**RE: Bronx Avenue- Urban Transportation Plan Amendment Submittal**

Hanson Professional Services, Inc. is requesting the removal of the Bronx Avenue roadway between Lipes Boulevard and Master Channel 31 from the Urban Transportation Plan and a modification to the Strategic Plan for Active Mobility Phase 1: Bicycle Mobility Plan to have an Off-Road Multi-Use Trail.

BRONX ROW  
AIRLINE CROSSING UNIT 3  
Corpus Christi, Nueces County, TX

### CROSS SECTIONS

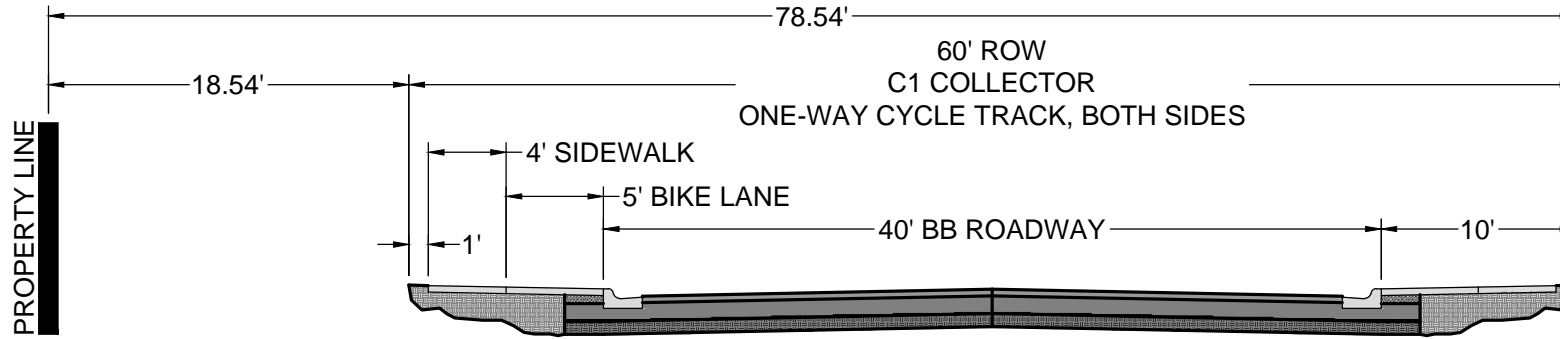
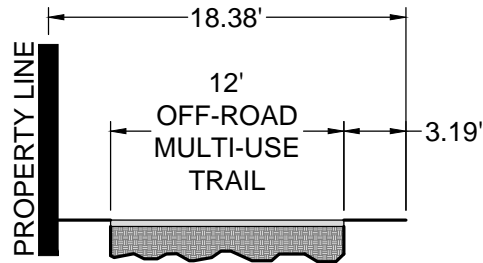
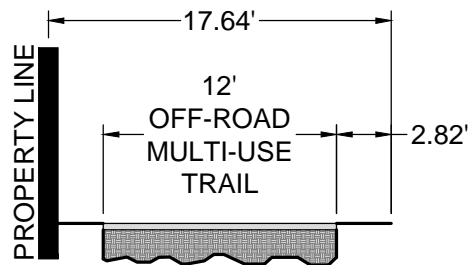
- Current cross section:
  - 60' wide C1 collector right of way: 40' back of curb to back of curb roadway (as per UDC), 1 way cycle track (both sides) (as per Strategic Plan for Active Mobility, Phase 1: Active Mobility Plan page 38 and 59): 4' sidewalk, 5' bike lane, 1' buffer on both sides, centerline aligned approximately on average 48.54' off from the west boundary of development

- Proposed cross section:
  - 12' off road multi-use trail hike/bike path aligned along west boundary of development in a dedicated ROW with an average width of 18'.
